A REPAIR

**ON-SITE SEWAGE DISPOSAL SYSTEM
HOWARD COUNTY HEALTH DEPARTMENT
BUREAU OF ENVIRONMENTAL HEALTH**

ADDRESS: 689 Ridge Road PROPERTY OWNER: Elaine Howes

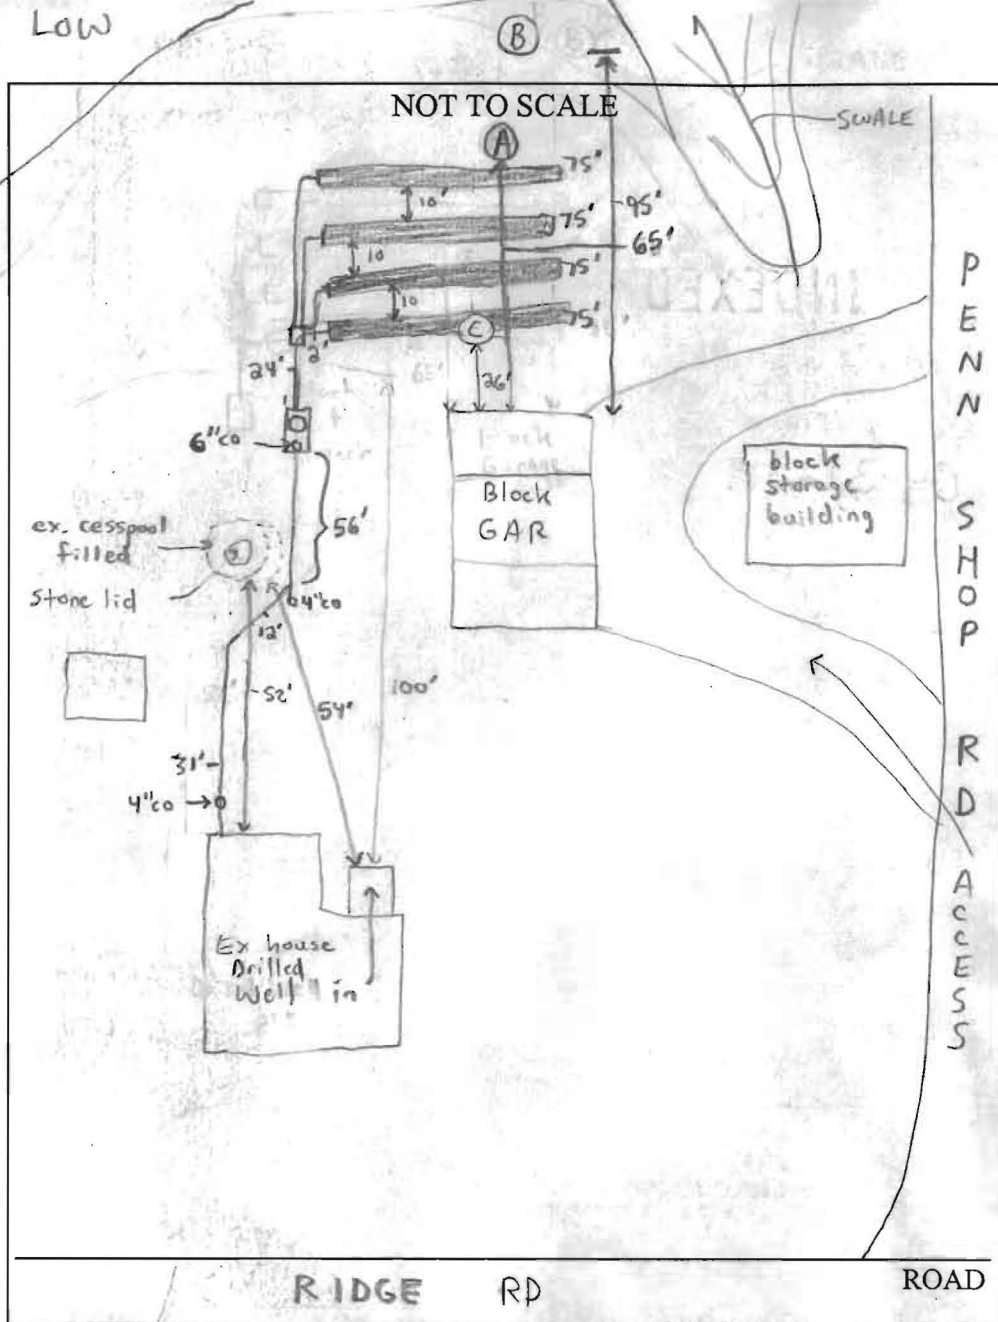
PRE-CONSTRUCTION 9/11/02- DUG HOLES IN LOCATIONS (A) (B) & (C) (SOILS MARGINAL) BUT HOLE (C) BEST, INSTALL NEW TANK & 4-75' TRENCHES -10' CENTER TO CENTER. ABANDON EX. CESSPOOL - (SRK)

INSTALLATION 10/9/02- TANK SET, 1ST TRENCH PARTIALLY FINISHED & DEEPER THAN SPECIFIED, OK TO CONTINUE, 1ST 50' OF 1ST TRENCH 7' DEEP, LAST 25' OF 1ST TRENCH 4.5' DEEP (1ST TRENCH STEPPED UP & PIPE LEVEL: 17' 14.5')

TRENCH 2 & 3 BOTTOMS AT 4.5, OK TO CONTINUE WORK - (SRK)

10/17/02- EX. CESSPOOL PUMPED & FILLED W/ STONE, ALL TRENCHES IN, OK TO COVER ALL WORK PER TELEPHONE CONVERSATION W/ INSTALLER (TIME CONSTRAINTS, MANAGEMENT / STAFFING ISSUES) DIDNT ALLOW FOR FINAL INSP. - (SRK)
